MEMORANDUM

To: Giovanni Zinn, City of New Haven
From: Jeremy Chrzan, PE, PTOE, LEED AP, Multimodal Design Practice Lead
Date: May 16, 2022

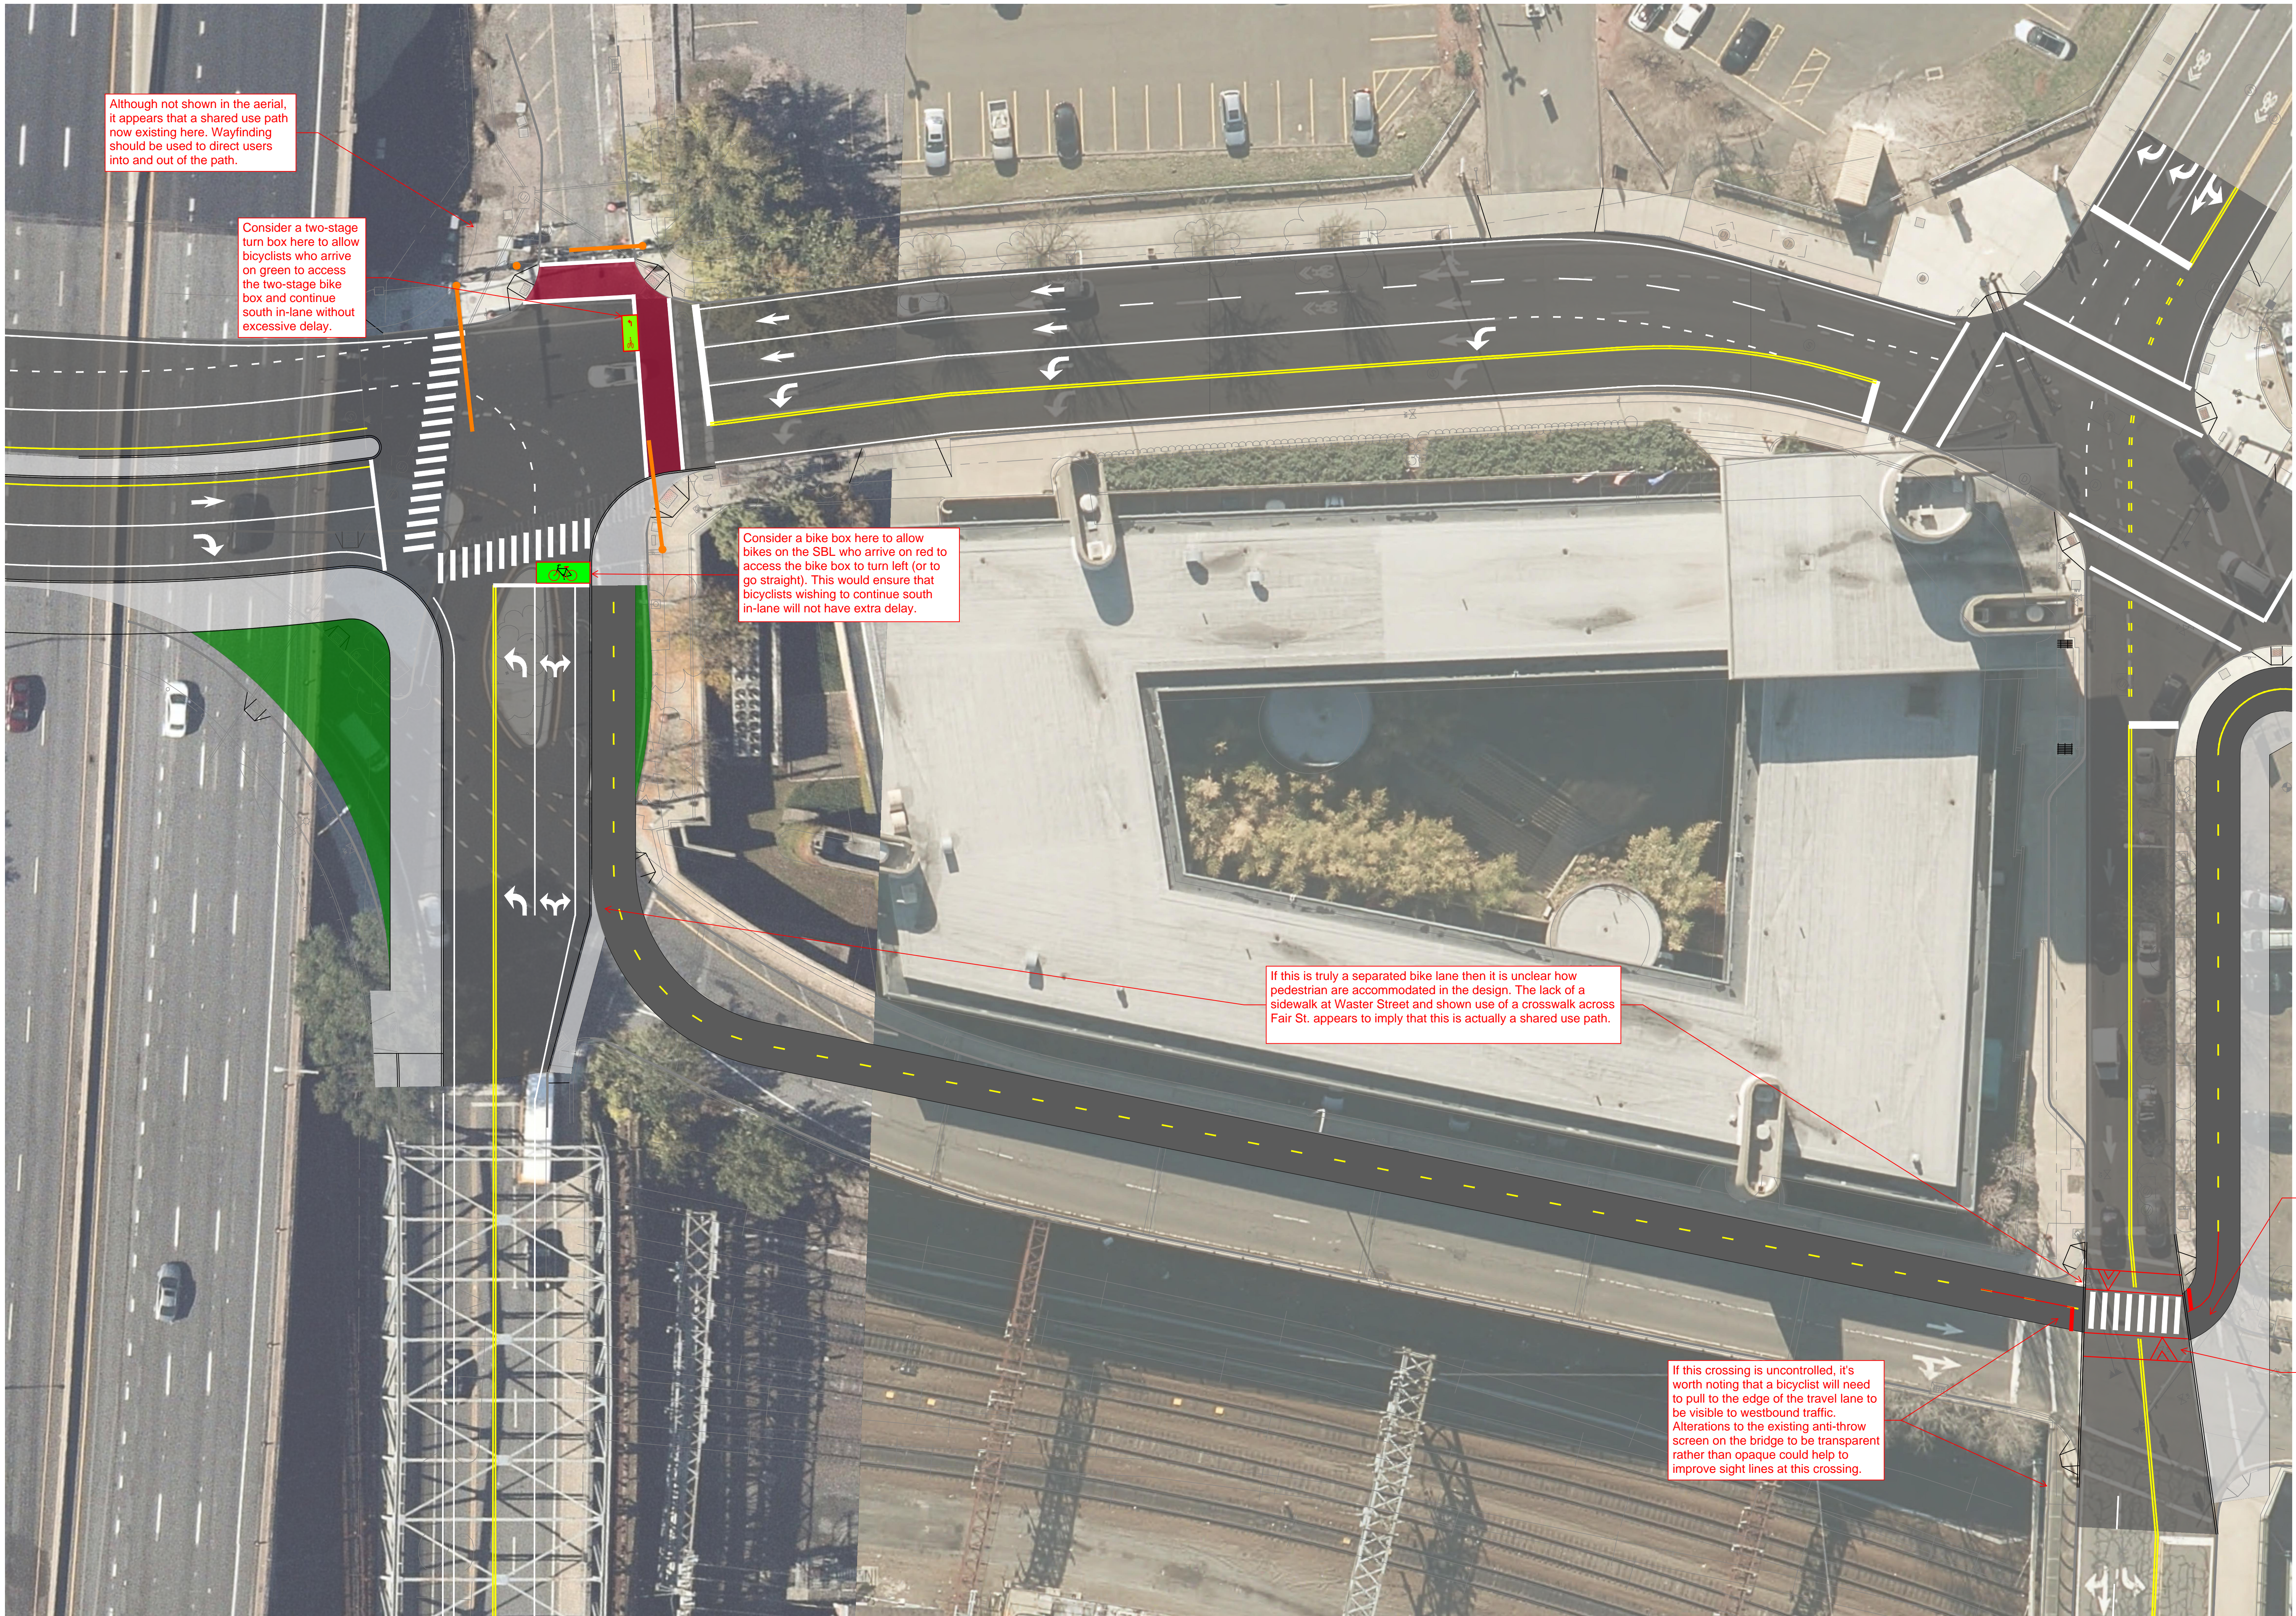
The proposed design requires bicyclists to cross the entering and exiting lanes of the station drop-off loop which introduces unnecessary conflicts between motorists and bicyclists. Given that this is the only uncontrolled driveway crossing proposed along the two-way separated bike lane, it would be ideal to remove those conflicts entirely, particularly as these are likely to be conflicts between buses and bicyclists. Additionally, the station is an origin and destination for bicycle trips, but the current design separates bicyclists from having direct access to the station and the bicycle parking canopy. As noted in the City's goals, the priority is to encourage modal shift away from single occupancy vehicles, along with bicycle, pedestrian, and transit options that complement each other. Moving the bicycle facility closer to the station will help to achieve this goal by creating direct links between transit and bicycle facilities. Lastly, as noted on the redlined plans, the current design in this vicinity will encourage pedestrians to use the separated bike lane as it will represent the straightest route for some pedestrian desire lines.
